**EXH. KKD-__X
DOCKET UE-210795
2022 PSE CEIP
WITNESS: KARA K. DURBIN**

**In the Matter of Puget Sound Energy's
Draft 2021 Electric Integrated Resource
Plan**

**COMMISSION STAFF COMMENTS REGARDING
PUGET SOUND ENERGY'S DRAFT INTEGRATED RESOURCE PLANS
SUBMITTED IN COMPLIANCE WITH
RCWs 19.405, 19.280 and WACs 480-90-238, 480-100-600 through-630,
ORDER 02 UNDER DOCKETS UE-180607 and UG-180608,
AND UNDER CONSOLIDATED DOCKETS UE-191023 AND UE-190698, Order R-601**

February 5, 2021

Figure 1-1: Electric Peak Hour Capacity Resource Need after Cost-effective Demand-side Resources ⁸

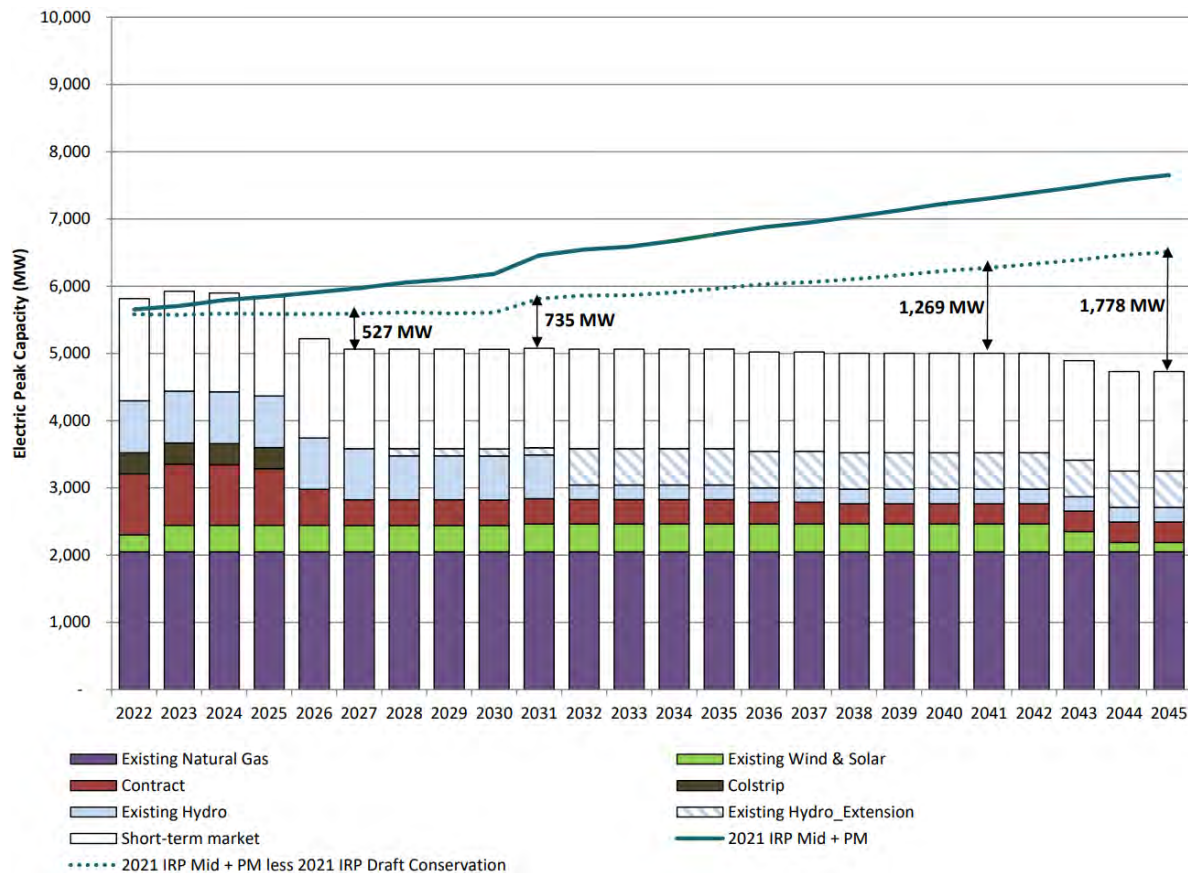
Capacity: During the 2019 IRP process, PSE forecasted a capacity shortage in the first year of the planning horizon, with a 685 megawatt (MW) resource deficiency in 2022.⁶ The company’s Draft IRP tells a different story. As shown in Figure 1-1, PSE now projects sufficient capacity through 2025, assuming cost-effective conservation and demand response is acquired as forecast,⁷ and if approximately 1,500 MW of short-term market resources are available. Staff notes in addition to availability, financial risk is also a tangible consideration as PSE’s market reliance position extends to upwards of 25% of its resource portfolio.

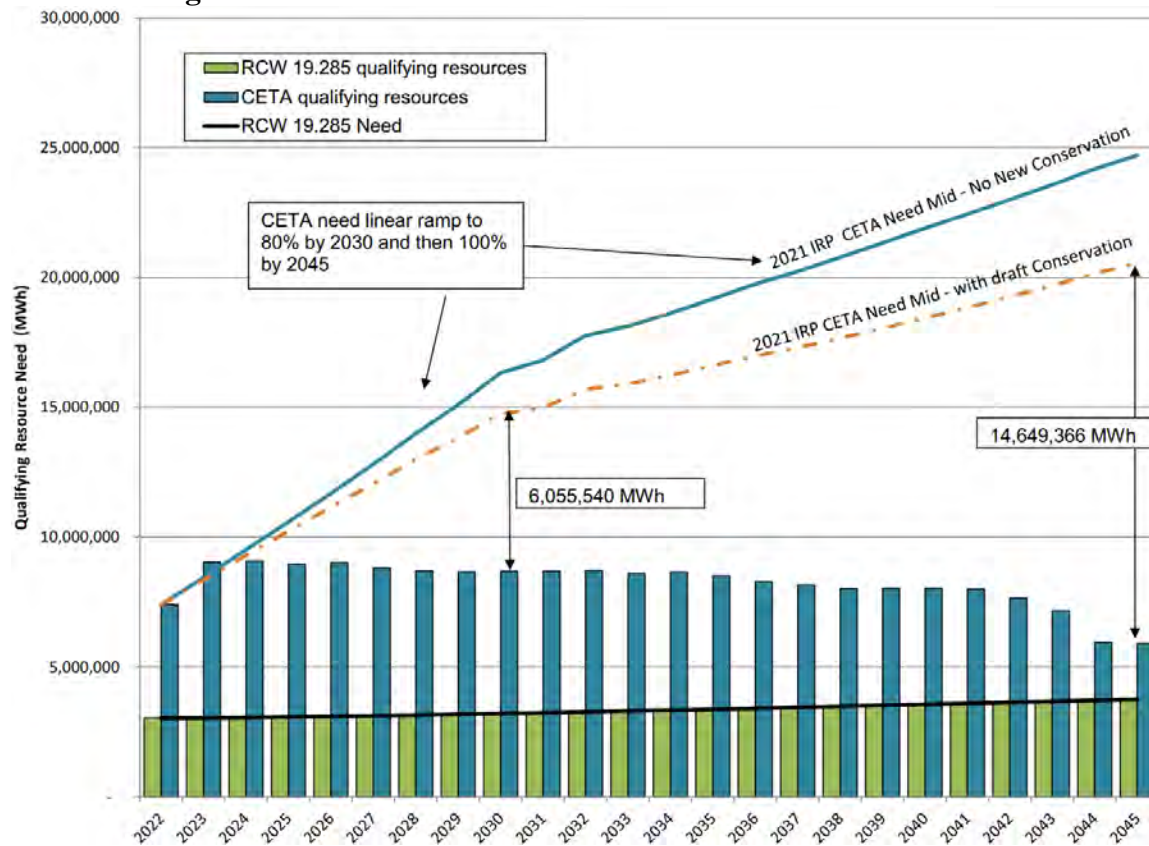
Energy: Comparing PSE’s forecasted annualized energy needs tells a similar story, with a noticeable reduction in average megawatts (aMW) in the more recent Draft IRP forecast. In the 2019 IRP process, PSE forecasted roughly 2700 aMW of annualized energy need in 2022, increasing to almost 3500 aMW by 2039.⁹ In the Draft IRP, the company forecasts just over 2500 aMW of system need in 2022, escalating to roughly 3300 aMW by 2045.¹⁰
